**HISTORIC AND DESIGN REVIEW COMMISSION**  
**October 18, 2023**

**HDRC CASE NO:** 2023-372  
**ADDRESS:** 102 HERMINE BLVD  
**LEGAL DESCRIPTION:** NCB 9007 BLK 13 LOT 40 AND 41  
**ZONING:** R-4, H  
**CITY COUNCIL DIST.:** 1  
**DISTRICT:** Olmos Park Terrace Historic District  
**APPLICANT:** Albert S Encinia | A.E. Secure Investments Corp.  
**OWNER:** Jeanette Campbell  
**TYPE OF WORK:** Demolition of a rear accessory and conceptual review of new construction of a rear accessory  
**APPLICATION RECEIVED:** August 21, 2023  
**60-DAY REVIEW:** October 20, 2023  
**CASE MANAGER:** Bryan Morales

The applicant is requesting a Certificate of Appropriateness for approval to demolish the rear accessory and conceptual approval of new construction of a 455 square feet structure.

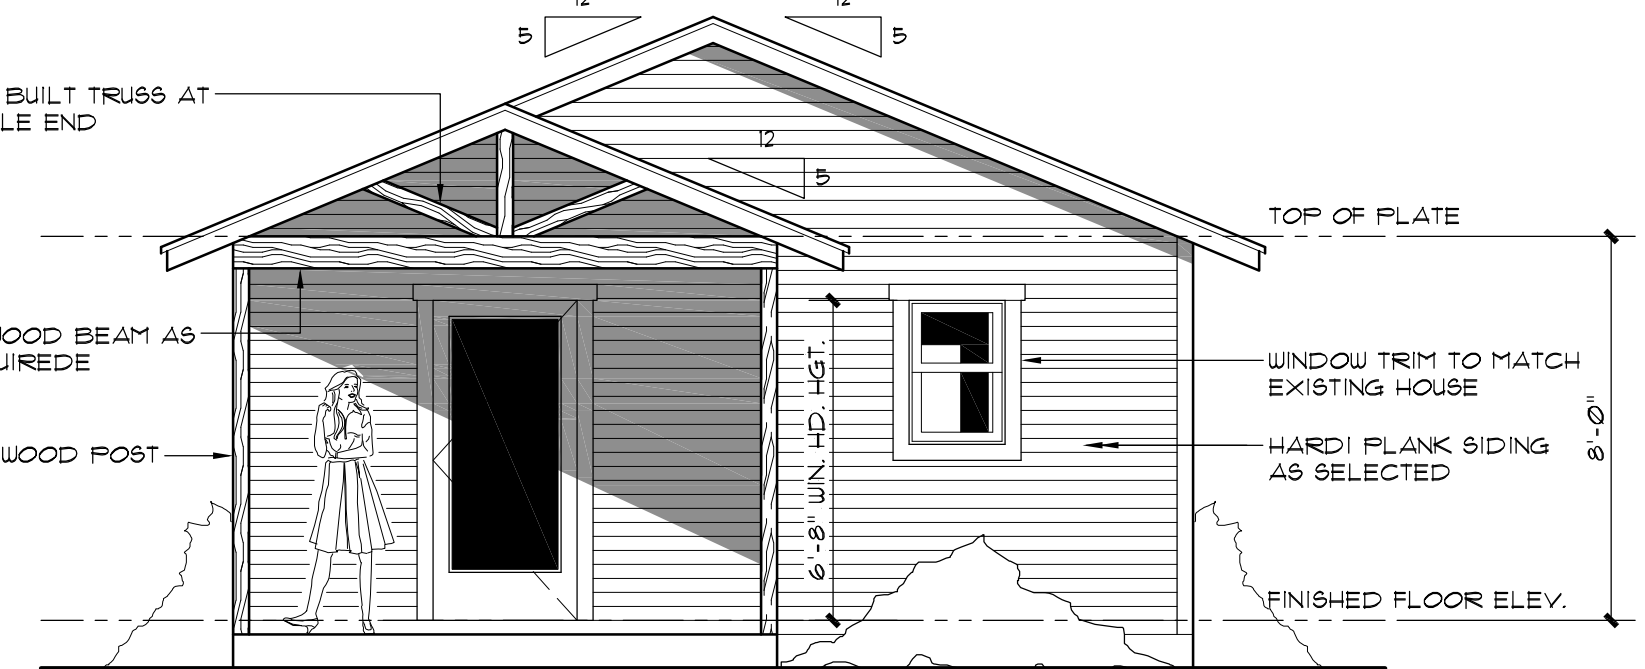
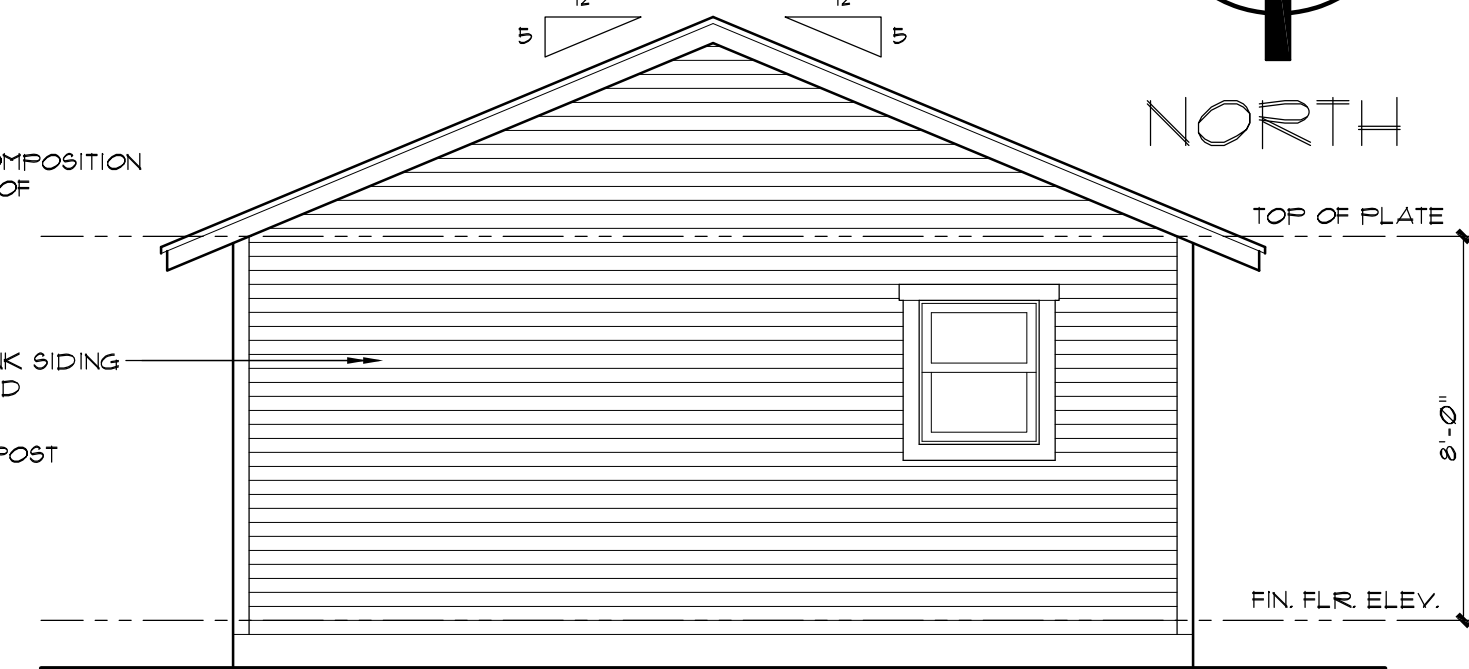
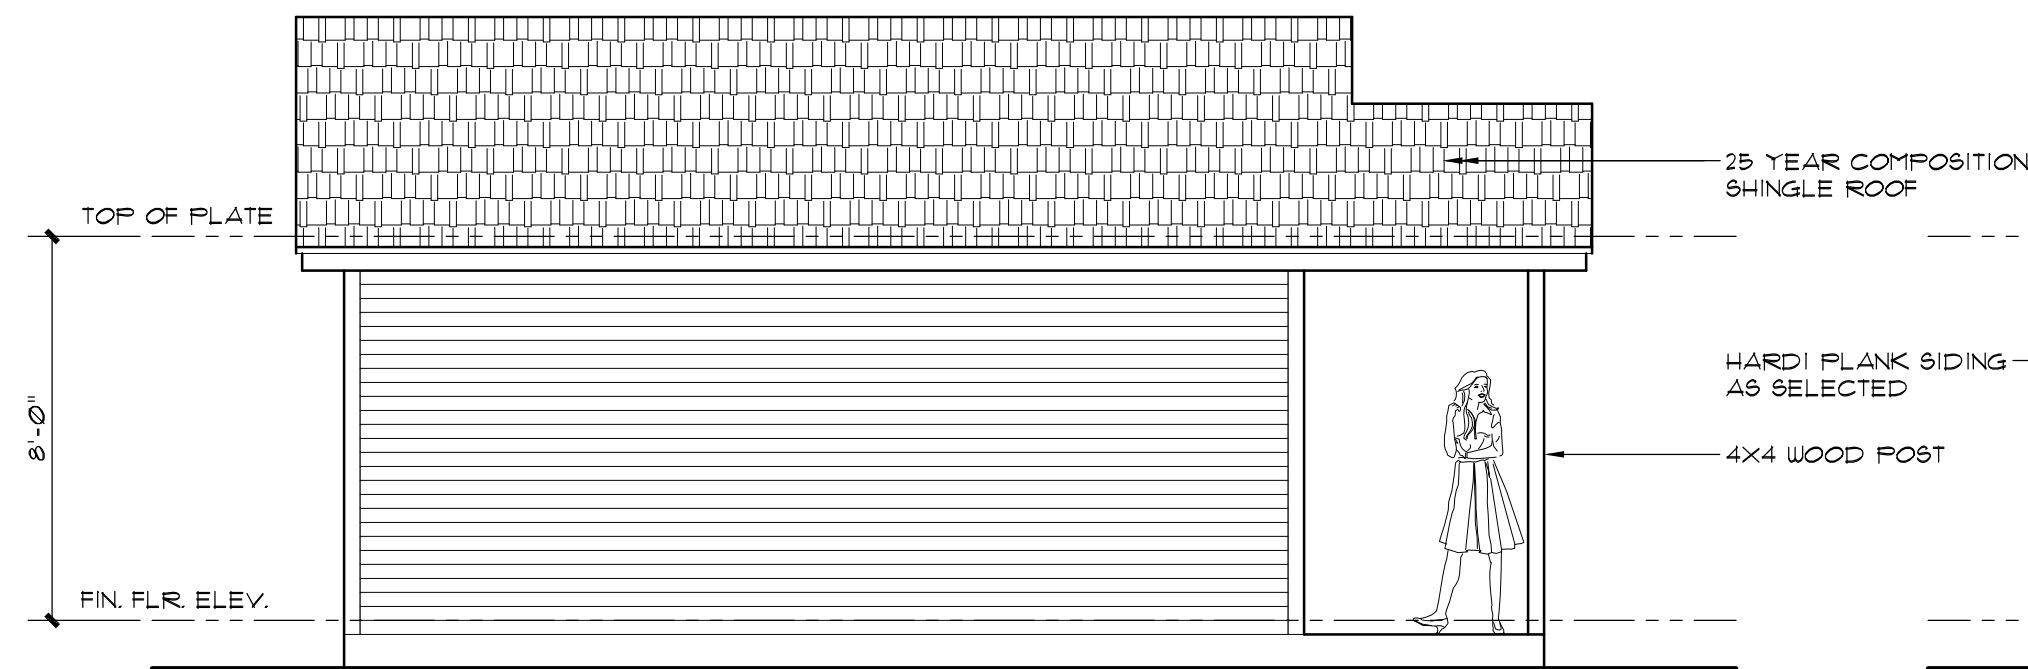
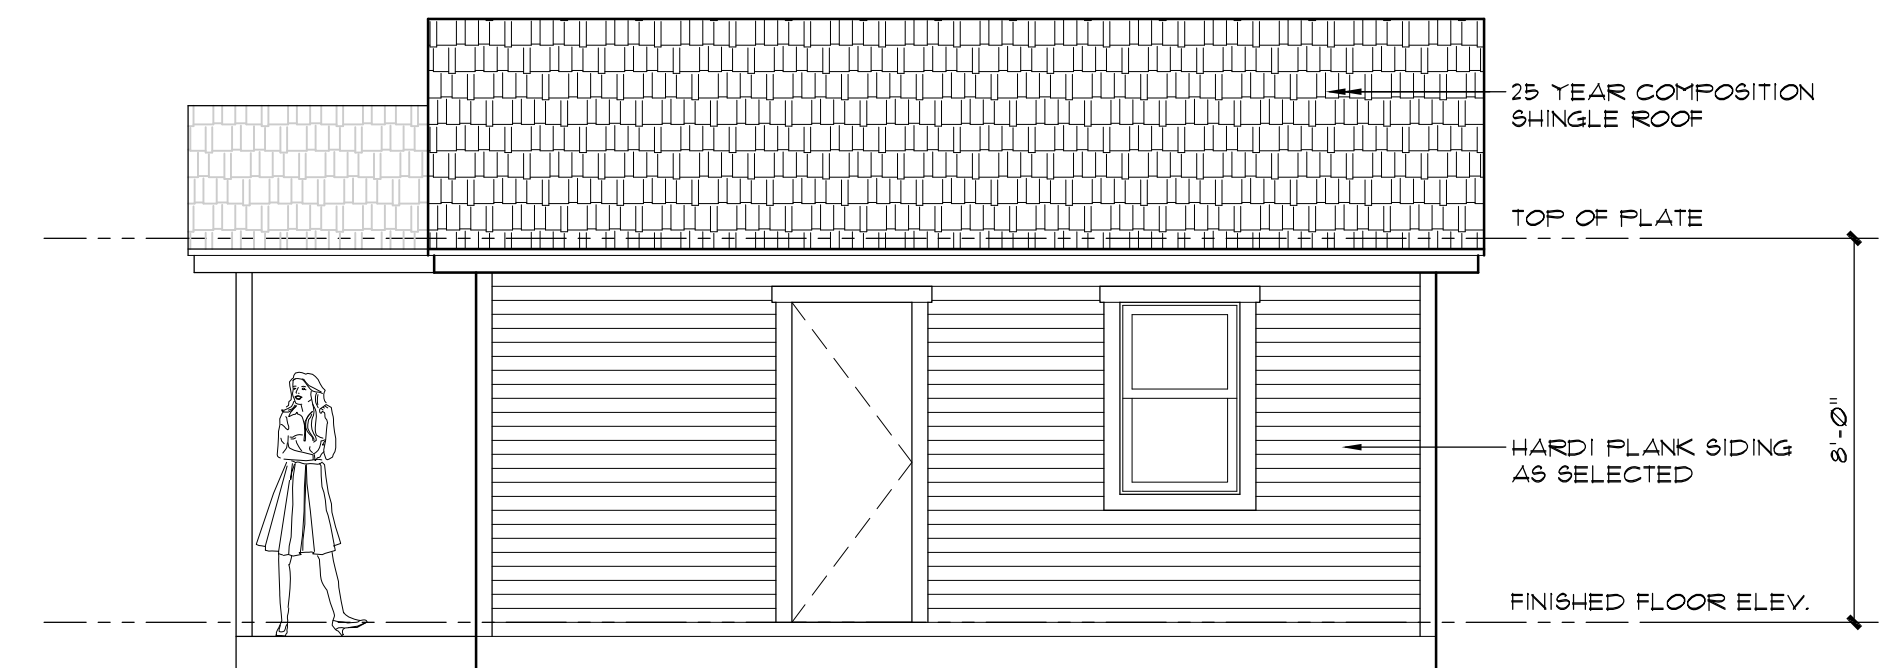
- f. **NEW CONSTRUCTION (REAR ACCESSORY STRUCTURE)** – The applicant is requesting conceptual approval to construct a one-story accessory structure at the rear of the property. The Guidelines for New Construction 5.A. notes that new outbuildings should be visually subordinate to the primary historic structure in terms of their height, massing, and form, and should be no larger in plan than forty percent of the primary historic structure's footprint. The existing primary structure on the lot features a footprint of approximately 1,214 square feet and one story in height. The proposed one-story accessory structure features a total footprint of approximately 455 square feet, or approximately 37% of the primary structure's footprint. Accessory structures on the block are predominately single story. Staff finds the proposed height and general massing conforms to guidelines.

- h. **ARCHITECTURAL DETAILS (MATERIALS)** – The applicant is requesting conceptual approval to construct a one-story accessory structure at the rear of the property with a composition shingle roof and Hardie plank siding. The Guidelines for New Construction 5.A.iii. and 5.A.iv. note that new accessory structures should relate to the period of construction of the primary historic structure on the lot by using complementary materials and simplified architectural details. Staff finds the proposed composition shingle roof generally conforms to guidelines. Staff finds the installation of fiber cement board siding generally appropriate; however, the siding should feature a reveal of 6 inches with the smooth side facing outward. New Construction 2.B.i states that roof forms—pitch, overhangs, and orientation—consistent with those predominately found on the block should be incorporated. Staff finds the proposed gable roof and its pitch conforms to guidelines.

- i. **ARCHITECTURAL DETAILS (FENESTRATION PATTERN)** – The applicant is proposing to install one single panel door on the north elevation, one flush metal door on the west elevation, and three one-over-one single sash windows on the south, north, and west elevations. The Guidelines for New Construction 2.C.i. related to window and door openings stipulates to incorporate window and door openings with a similar proportion of wall to window space as typical with nearby historic facades. Staff finds the proposed fenestration pattern generally appropriate.

Staff recommends conceptual approval of the replacement structure, based on findings a and f through j, with the following stipulations:

- i. That the hardie siding be installed with a maximum 6-inch reveal and the smooth side facing outward for the rear accessory structure.
- ii. That the applicant install windows that meet staff's standard window stipulations and submits updated specifications to staff for review and approval. The windows should feature an inset of two (2) inches within facades and should feature profiles that are found historically within the immediate vicinity. Meeting rails must be no taller than 1.25" and stiles no wider than 2.25". White manufacturer's color is not allowed, and color selection must be presented to staff. There should be a minimum of two inches in depth between the front face of the window trim and the front face of the top window sash. This must be accomplished by recessing the window sufficiently within the opening or with the installation of additional window trim to add thickness. Window trim must feature traditional dimensions and architecturally appropriate sill detail. Window track components must be painted to match the window trim or concealed by a wood window screen set within the opening.

8 WINDOW SCHEDULE  
SCALE: 1/4" = 1'-0"

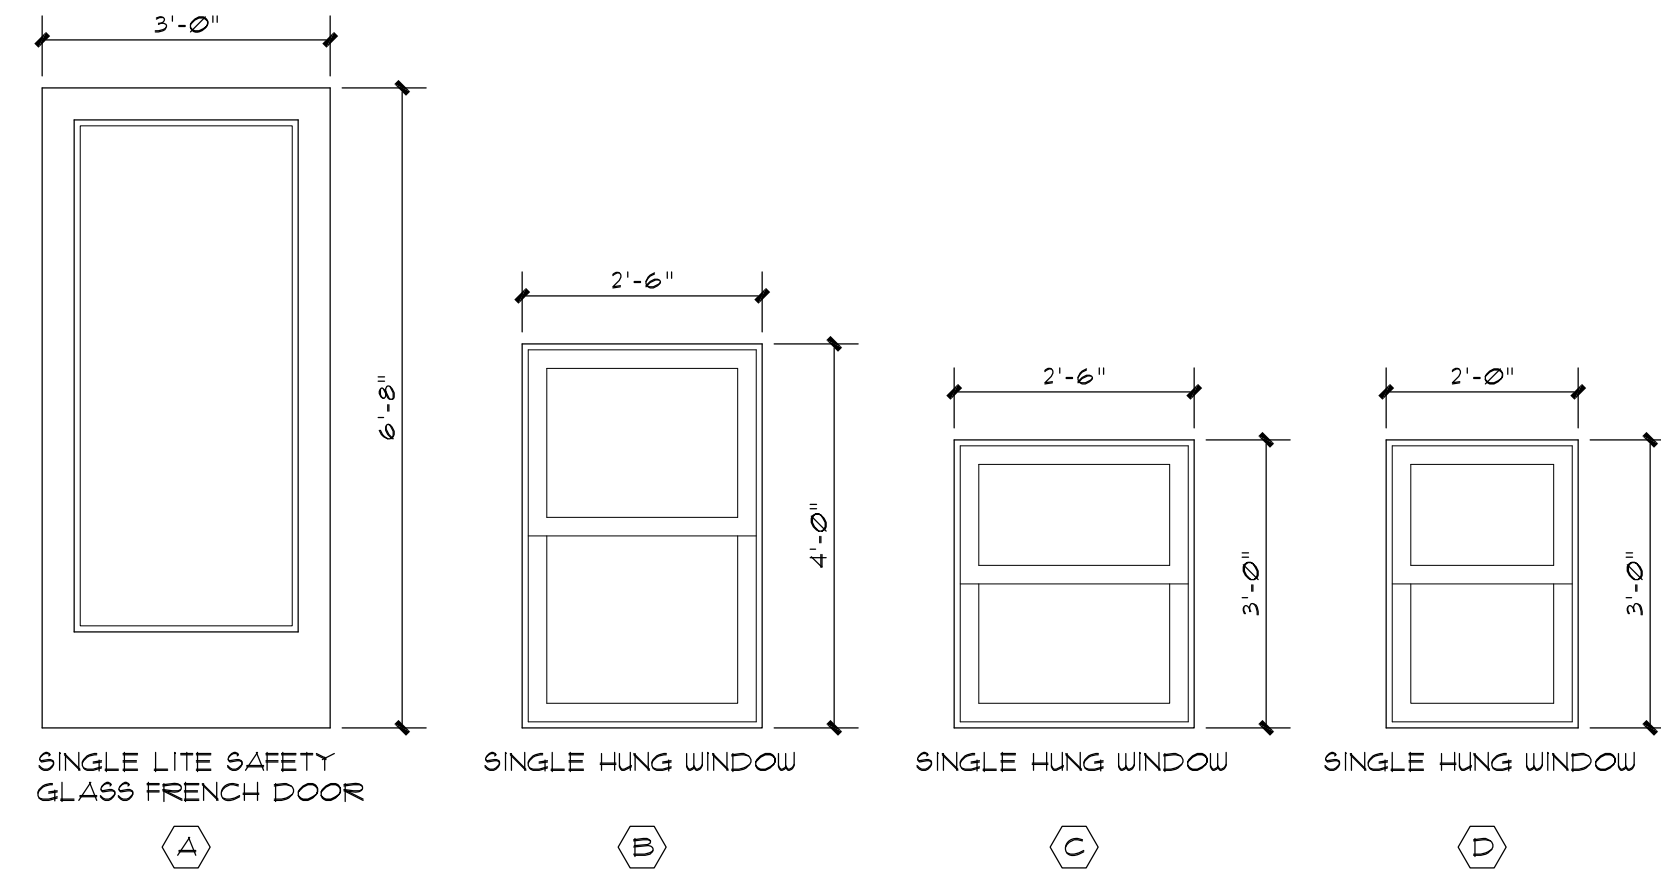
- j. **WINDOWS (MATERIALS)** – The applicant has not provided material information on the proposed windows and the door on the north elevation. Per *Standard Specifications for Windows in New Construction*, new windows on new construction should relate to the windows of the primary historic structure in terms of materiality and overall appearance. Windows used in new construction should be similar in appearance to those commonly found within the district in terms of size, profile, and configuration. Staff recommends that the applicant install wood or aluminum-clad wood windows on the rear accessory structure. An alternative window material may be proposed, provided that the window features meeting rails that are no taller than 1.25" and stiles no wider than 2.25".
